# WL1835MOD C2PC Details

**Revision 3.0**

**April 22, 2019**

The purpose of this document is to request a C2PC on our existing WL18MODGB modular certification (FCC ID: Z64 - WL18SBMOD, ISED ID: 451I-WL18SBMOD, test grades 01, 05, 31 and 35). The change will be to the OEM installation instructions to include a minimum cable loss. The parts in question can be seen below:

Figure 1: WL18MODGB mounted on WL1835MODCOM8B EVM

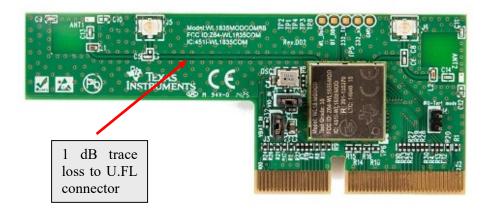
Our original filing was done with the WL18MODGB placed on the WL1835MOCOM8B evaluation board. The trace loss from the output of the main antenna to the U.FL connector is 1dBm as show in Figure 1 below.

Figure 2: WL18MODGB mounted on WL1837MODCOM8B EVM

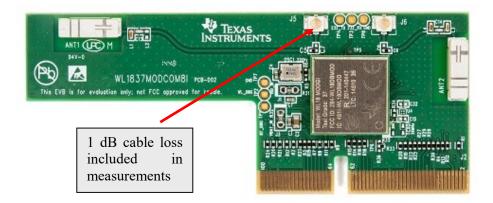
Testing was also performed with the WL18MODGB Test grade 35 placed on the WL1837MODCOM8I evaluation board. During the testing a 1dB cable loss was included in the measurements as shown in Figure 2. Results of the test (to be supplied by Sporton) show no measureable difference in output power as the original grant.

Based on the above information we are requesting that a C2PC be performed allowing customers to include an equivalent 1dB loss of any shape or form (such as trace, cable or 1-dB pi-pad loss) in their design and maintain the use of the current FCC and ISED IDs. The integrator guide provided to customers will be updated to reflect this with the following statement:

Note: at least an equivalent 1dB loss (in the form of trace, cable or 1-dB pi-pad loss) is required between the output of the WL18MODGB module and the antenna to be compliant with the current Z64- WL18SBMOD and 451I-WL18SBMOD module certification.
